CITY OF ALBUQUERQUE

**RE: Champion Xpress Car Wash
5307 4th Street NW
Grading and Drainage Plan
Engineer's Stamp Date: 05/09/22
Hydrology File: F14D036A**

Based upon the information provided in your submittal received 05/09/2022, the Grading & Drainage Plan **is not** approved for Building Permit and SO19 Permit. The following comments need to be addressed for approval of the above referenced project:

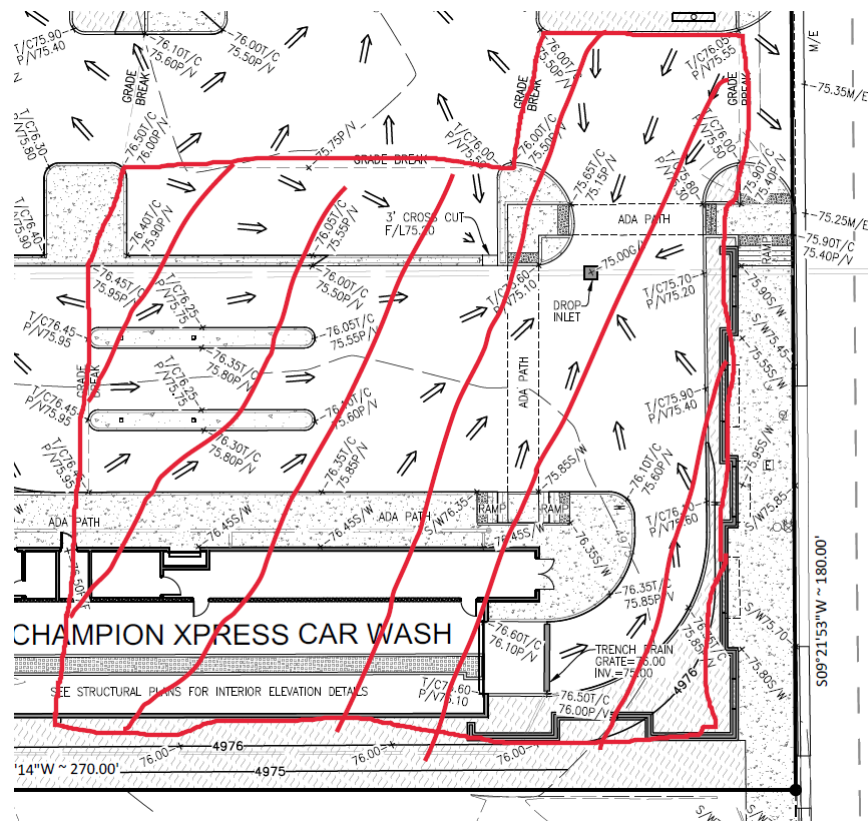
1. The property to the southwest currently has a building, sidewalks and landscaping within Douglas MacArthur Rd R.O.W. None of this existing information is shown and there is shown proposed new sidewalk and an access road through this property.

2. I know that the owner of the property to the southwest and this project's tract is the same, Hydrology still needs a written consent to do grading and construction on that property.
3. Per the IDO § 6-4(Q), the property owner of the property is responsible for building sidewalk along the adjacent R.O.W. of the project. This project is only adjacent to 4th Street, which already has a sidewalk. Not sure why any of this work is being done.

Please contact Transportation to confirm the need of replacing the existing sidewalk along 4th Street and the work along Douglas MacArthur which is not adjacent to this project.

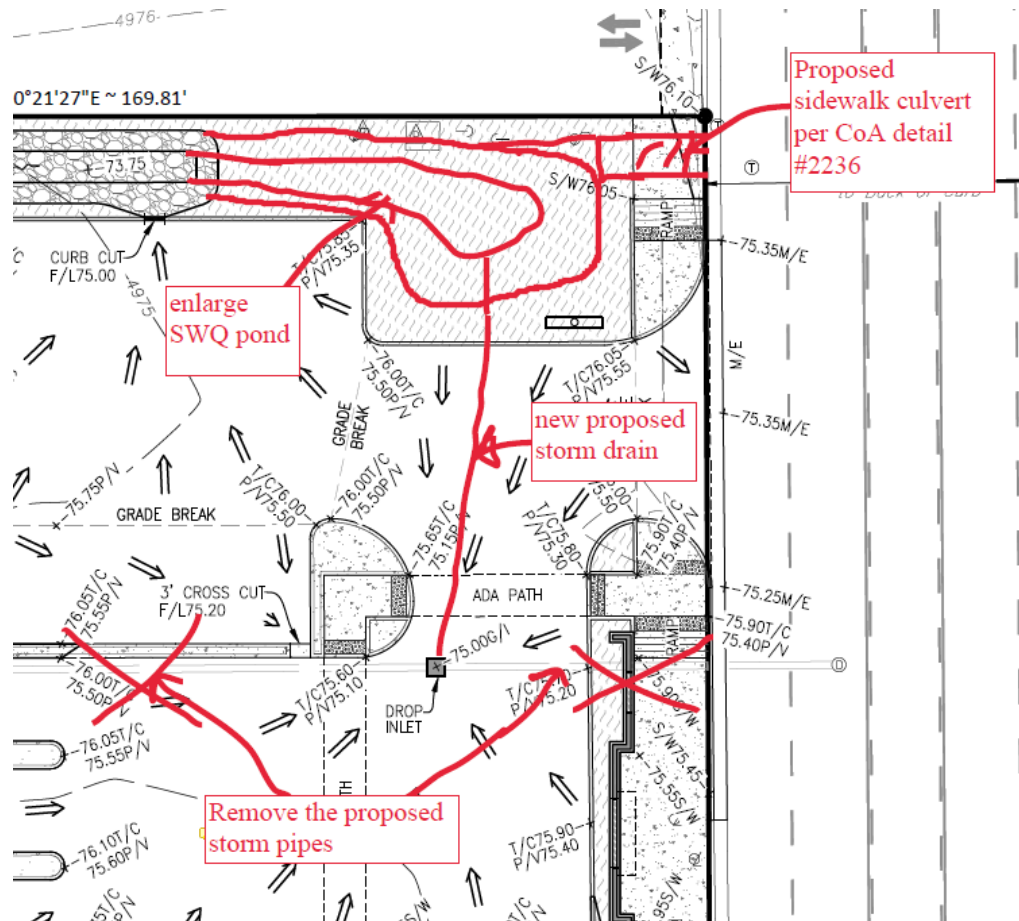
6. Please show all storm pipe sizing, inlet grate elevations and inverts on the Grading & Drainage Plan.
7. The shown drainage area appears to not get discharged into a stormwater quality pond prior to leaving the property. This cannot directly discharge into the City's storm drain system without doing so. This site has lots of landscape areas to provide the required SWQV.

8. A possible solution to Comment #7 is to direct the inlet to the landscape area and enlarge the stormwater quality pond. Also, the outlet for the pond can be a sidewalk culvert on 4th Street.

GRADING PLAN

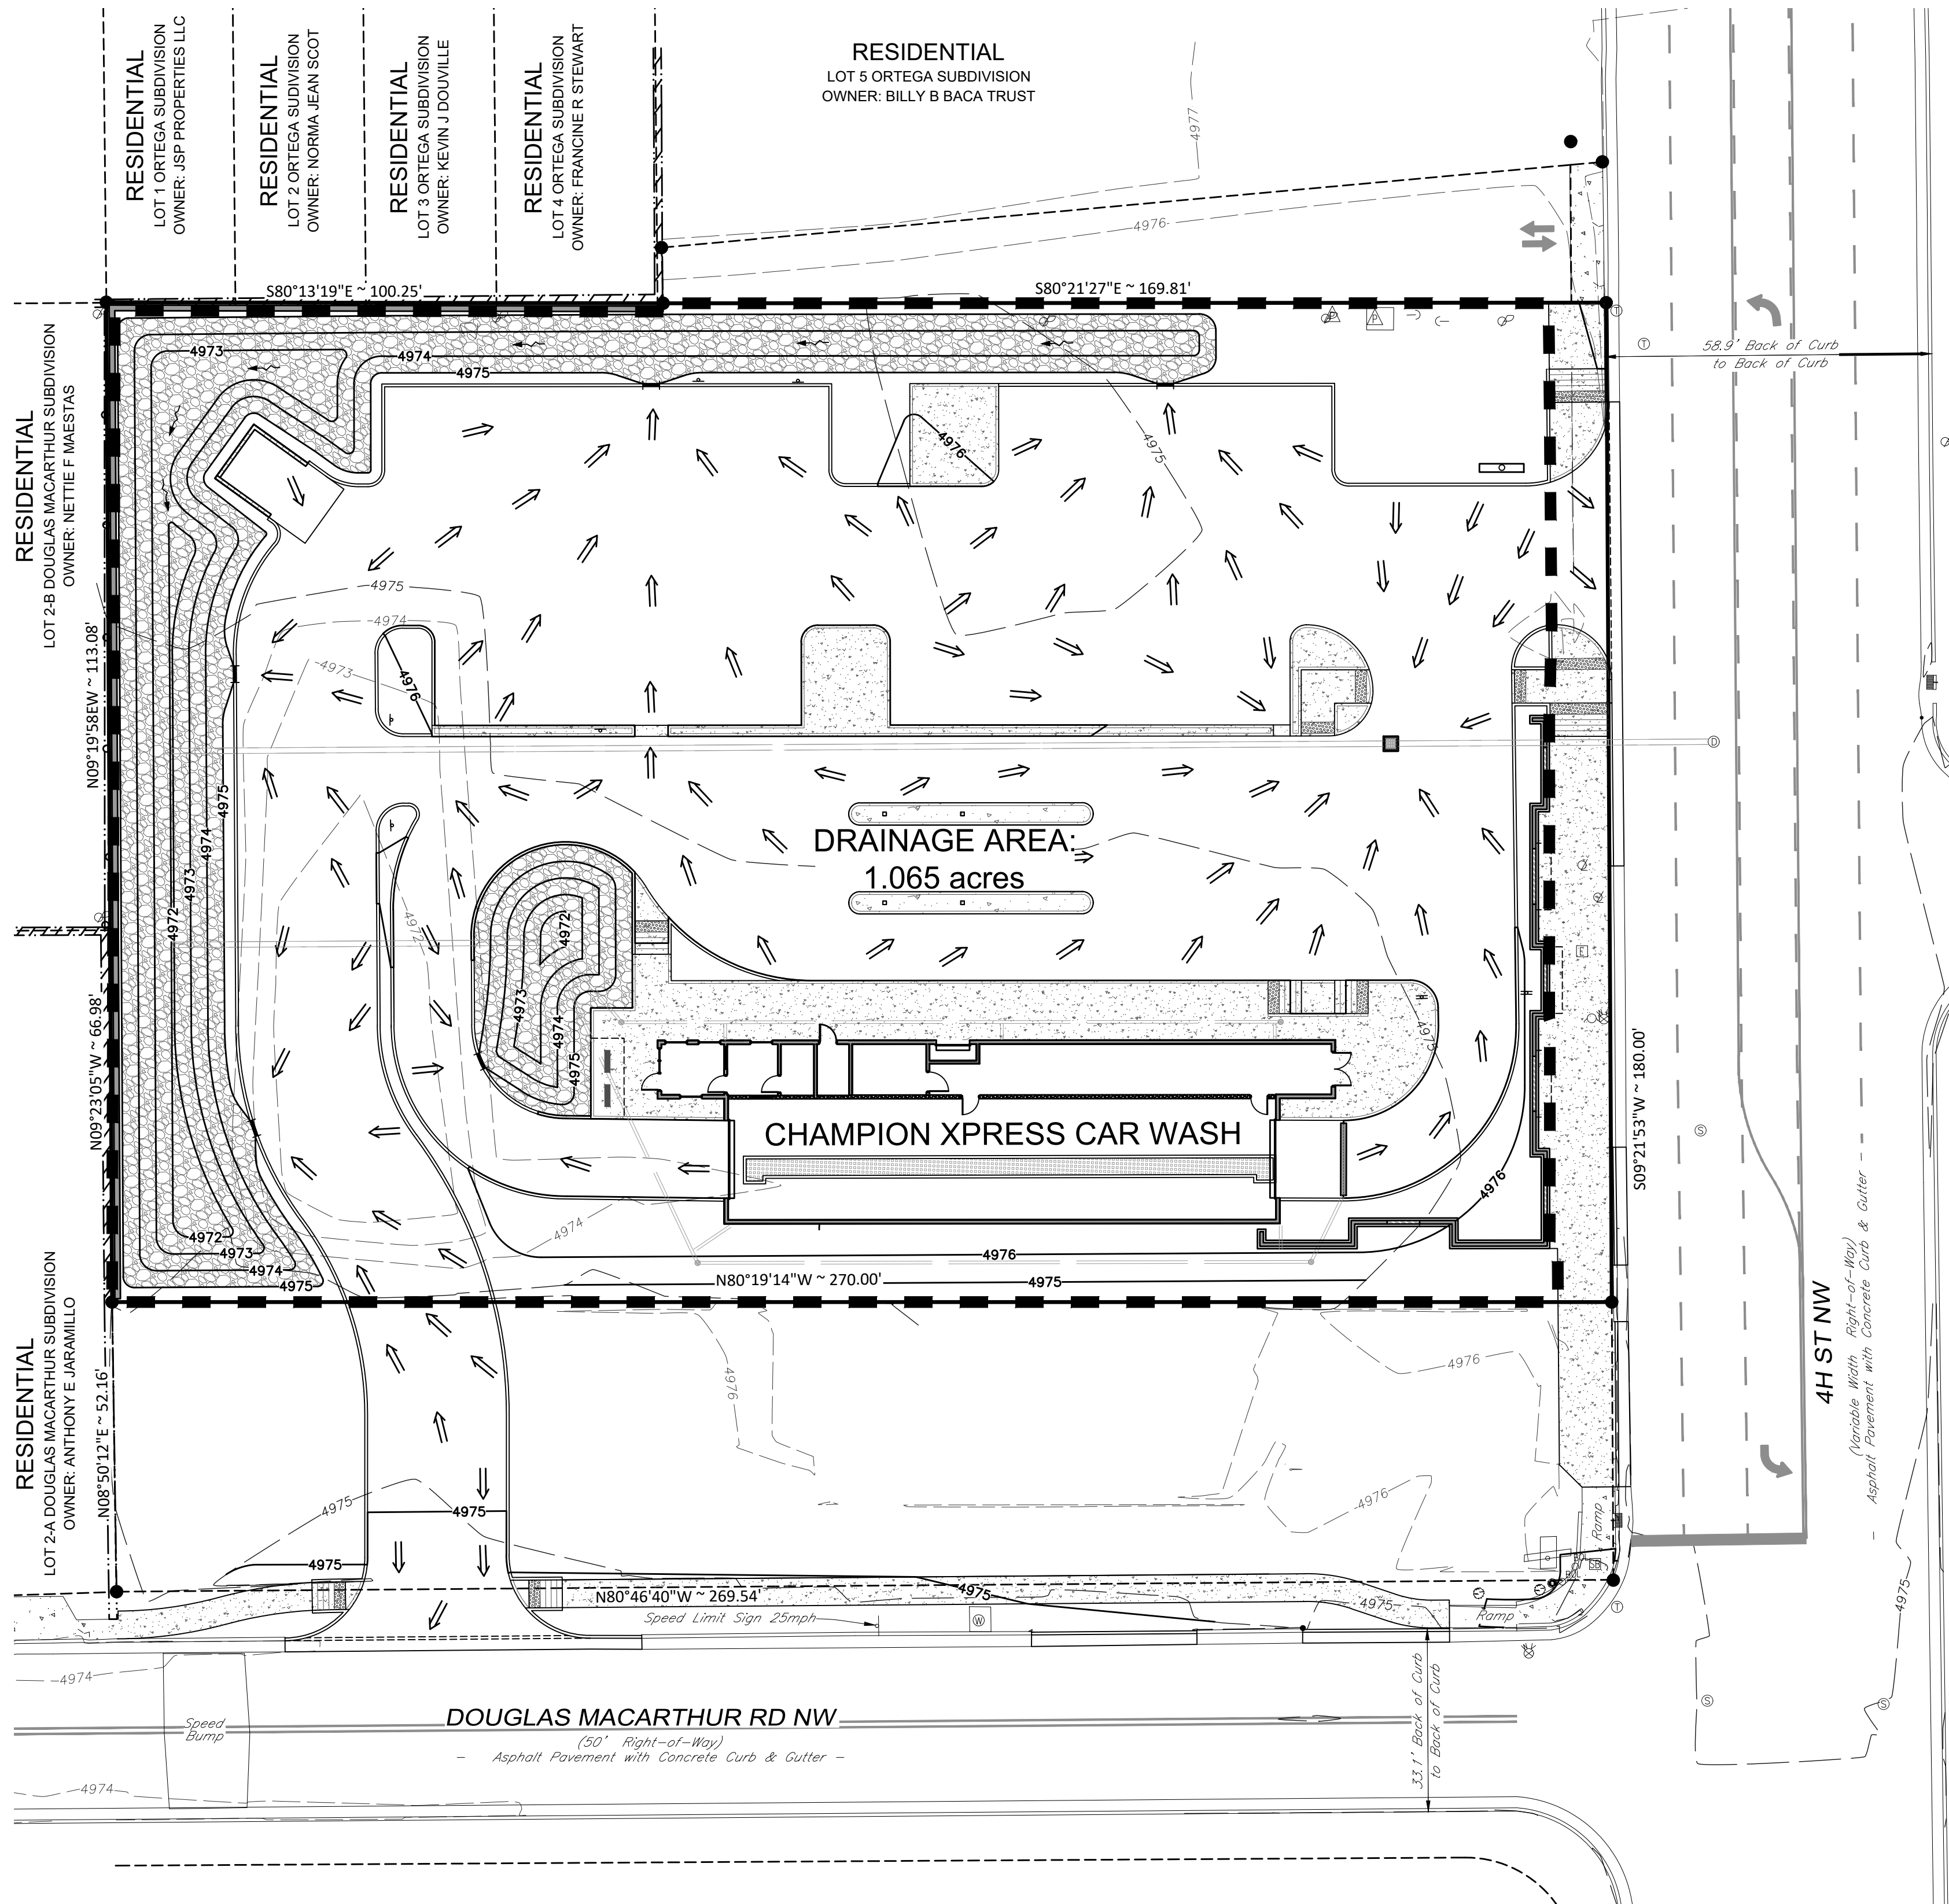
4. The calculations provided for the management onsite for the Stormwater Quality Volume (SWQV) is incorrect. The calculations used the number for a redevelopment and this site is new development. Therefore, per DPM Article 6-12 Stormwater Quality and Low-Impact Development for the sizing calculations. To calculate the required SWQV, multiply the impervious area draining to the BMP by 0.42 inches for new development sites.

5. Please provide the weir calculations, per DPM Article 6-16(A), for the curb cuts and sidewalk culverts. A coefficient of 2.7 is typically used for the weir equation $Q = CLH^{2/3}$.
